**CARLETON PLACE ARENA  
ADDITION AND RENOVATIONS  
75 Neelin Street Carleton Place, Ontario**

**CIR #8 Detailed Summary**

## CIR Response

CIR #08

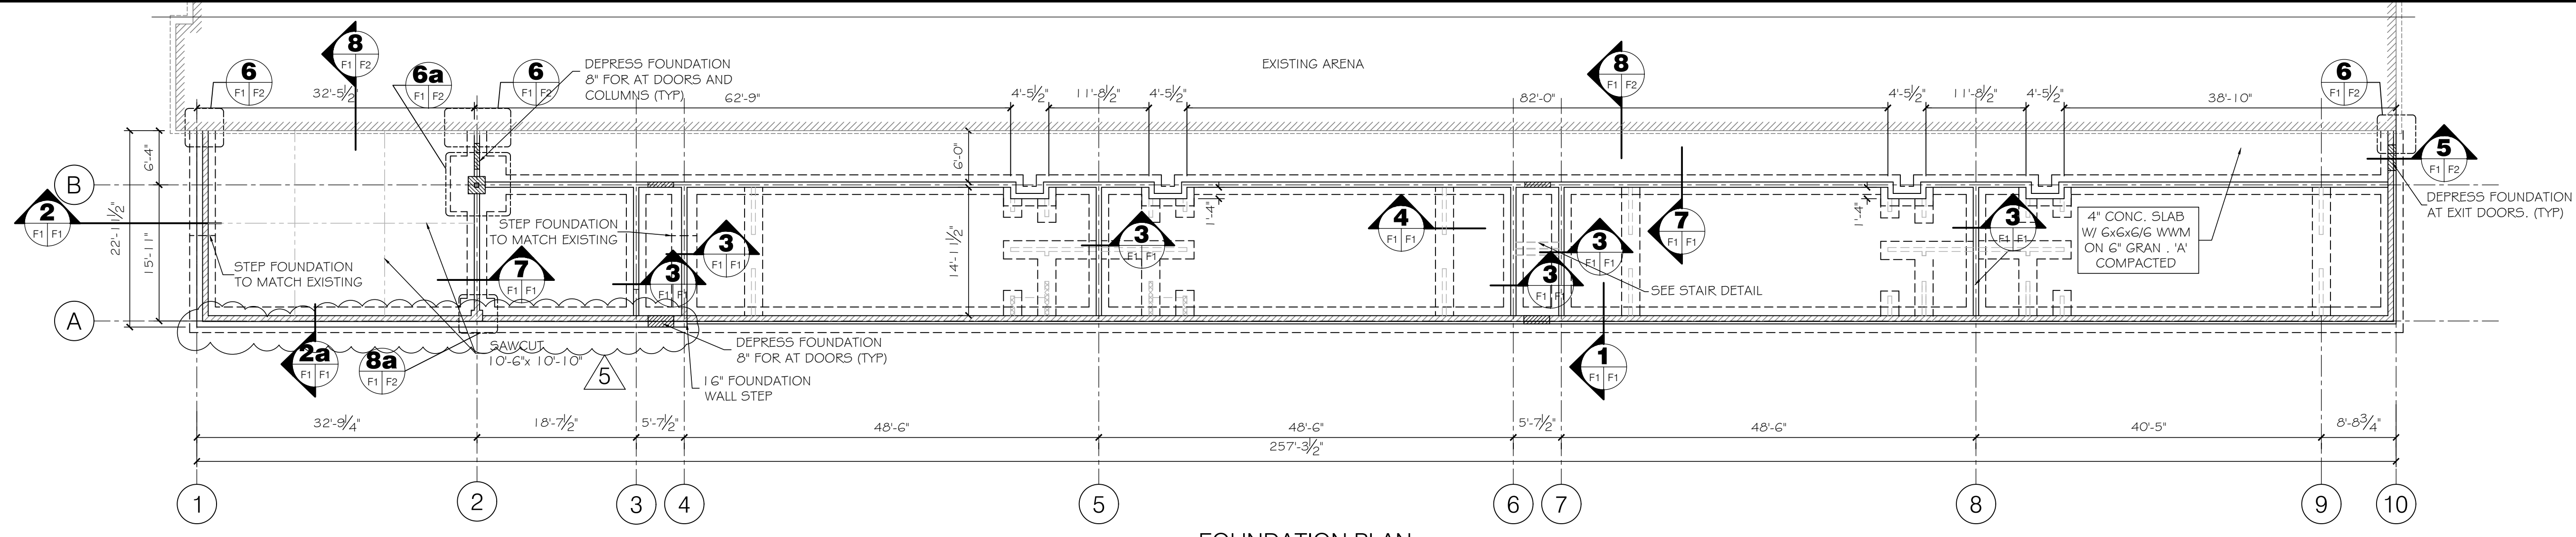
a. Does the foundation wall system step down along GL-2 from GL-A towards the existing building so that Footing Pad **6a-F1/F2** is at the same depth elevation as the existing footings or does this wall system including this new footing pad stay at the typical 5'-0" frost wall depth and the foundation wall system past this new footing pad get tied into the existing foundations as per detail **6-F1/F2** at the existing footing depth?

Foundation steps are arbitrarily shown near the existing foundation to indicate to the concrete that the footing must be stepped to match the existing footing elevation. The footing must be found on undisturbed native soil which will only be encountered at the existing footing elevation. The contractor can shift the location of the steps to accommodate how they would like to execute the pour, however the maximum 24"x24" step must be maintained. We expect that Pier 6a will need to be lower.

**F1**

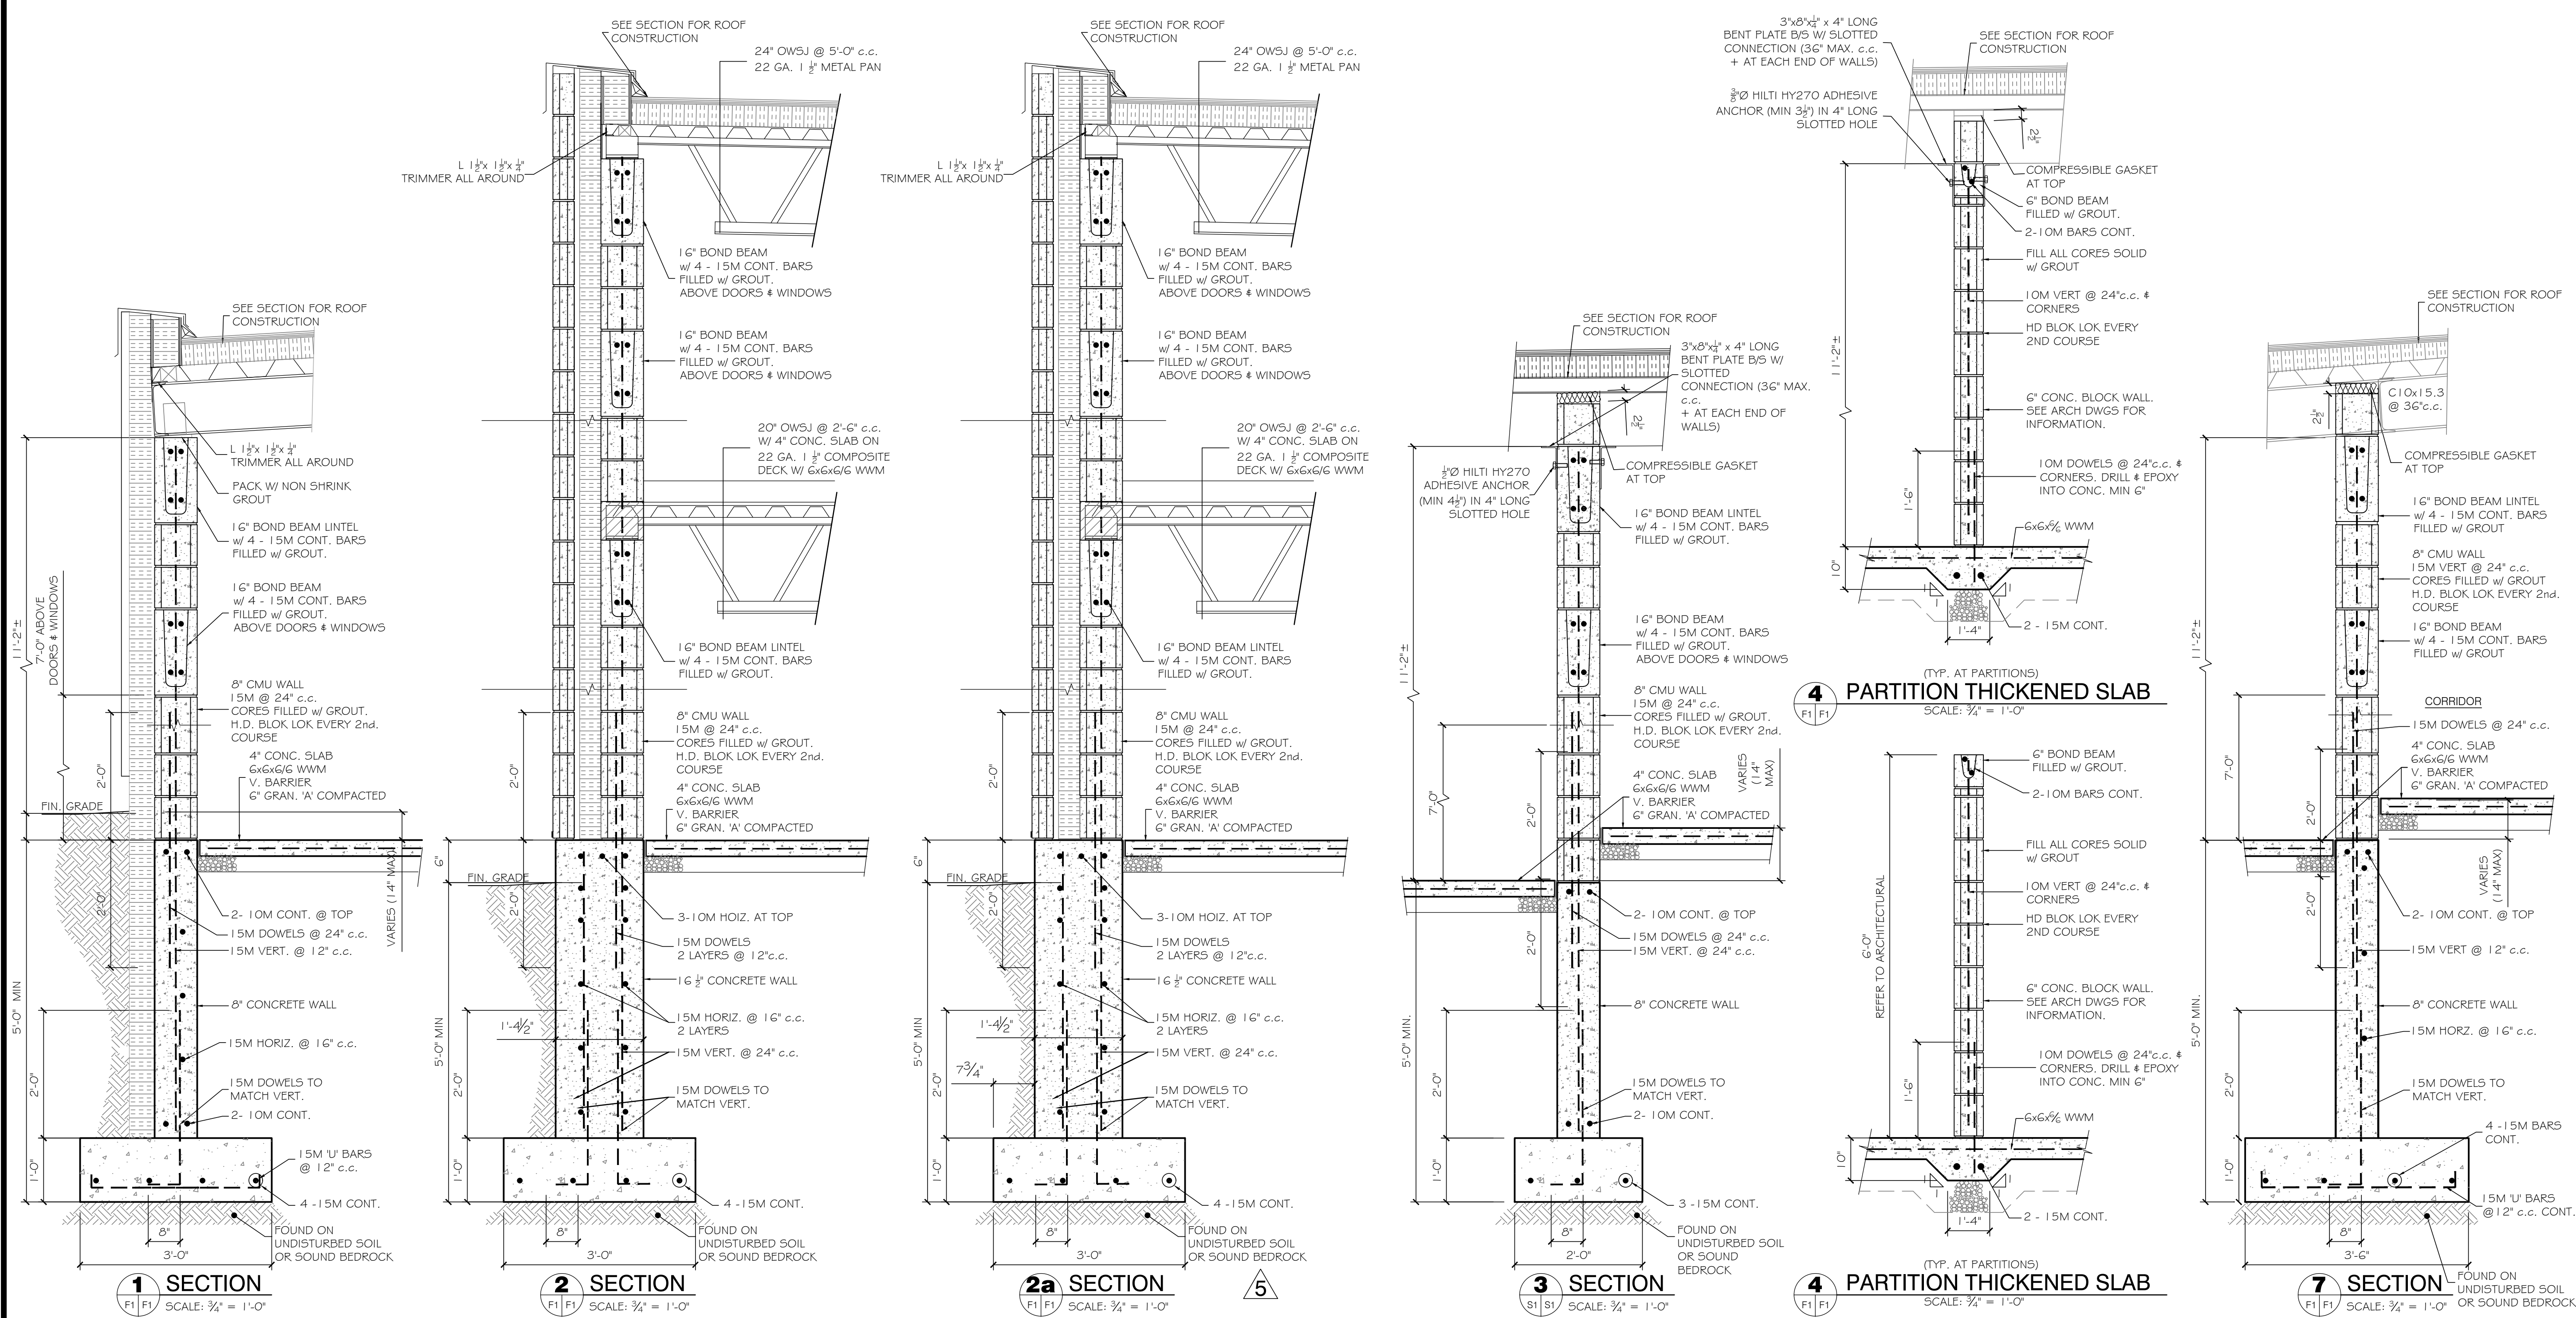
1. Elevation depth clarifications are required for Footing Pad **6a-F1/F2** on GL-2. According to the drawing details and cross sections, it appears that Footing Pad **6a-F1/F2** remains at the same typical 5'-0" frost-wall elevation as the rest of the new foundation wall systems. However, the actual detail indicates that this new footing pad is to be constructed on "*undisturbed soils or solid bedrock*" and not Engineered Backfill. Additionally, this new footing pad is extremely close to the existing building and detail **6-F1/F2** appears to indicate a tie-in at the existing footing depth.

- a. Does the foundation wall system step down along GL-2 from GL-A towards the existing building so that Footing Pad **6a-F1/F2** is at the same depth elevation as the existing footings or does this wall system including this new footing pad stay at the typical 5'-0" frost wall depth and the foundation wall system past this new footing pad get tied into the existing foundations as per detail **6-F1/F2** at the existing footing depth?

- b. Note, there does not appear to be any step footings indicated for the foundations on GL-2, but there are for GL-4. Is the arrow on Drawing F1 pointing to the incorrect GL? If not, please clarify the requirement of step footings along GL-4 as these foundations do not tie-in to the existing foundations. As well, provide details of exactly where the foundations step down and then step back up again to meet with the typical 5'-0" frost wall foundations along GL-B (Detail 7-F1/F2).

2. Does the "L-shape" component at the bottom of Detail 6-F1/F2 represent the strip footing of the existing building foundations?

1. Elevation depth clarifications are required for Footing Pad **6a-F1/F2** on GL-2. According to the drawing details and cross sections, it appears that Footing Pad **6a-F1/F2** remains at the same typical 5'-0" frost-wall elevation as the rest of the new foundation wall systems. However, the actual detail indicates that this new footing pad is to be constructed on "*undisturbed soils or solid bedrock*" and not Engineered Backfill. Additionally, this new footing pad is extremely close to the existing building and detail **6-F1/F2** appears to indicate a tie-in at the existing footing depth.

b. Note, there does not appear to be any step footings indicated for the foundations on GL-2, but there are for GL-4. Is the arrow on Drawing F1 pointing to the incorrect GL? If not, please clarify the requirement of step footings along GL-4 as these foundations do not tie-in to the existing foundations. As well, provide details of exactly where the foundations step down and then step back up again to meet with the typical 5'-0" frost wall foundations along GL-B (Detail 7-F1/F2).

2. Does the "L-shape" component at the bottom of Detail 6-F1/F2 represent the strip footing of the existing building foundations?

The detail requires 5'-0" minimum, it can be deeper than this to suit the existing foundations. 5'-0" is the minimum frost depth but can go lower.

All foundations that must be over excavated to encounter native soil or tie into the existing foundation will need to be steeped. It is likely that the original foundation excavation included portions of the building receiving new foundation wall. Undisturbed soil will likely be at the existing footing elevation.

Yes. The "bump out" at the bottom would represent the existing foundation strip footing.
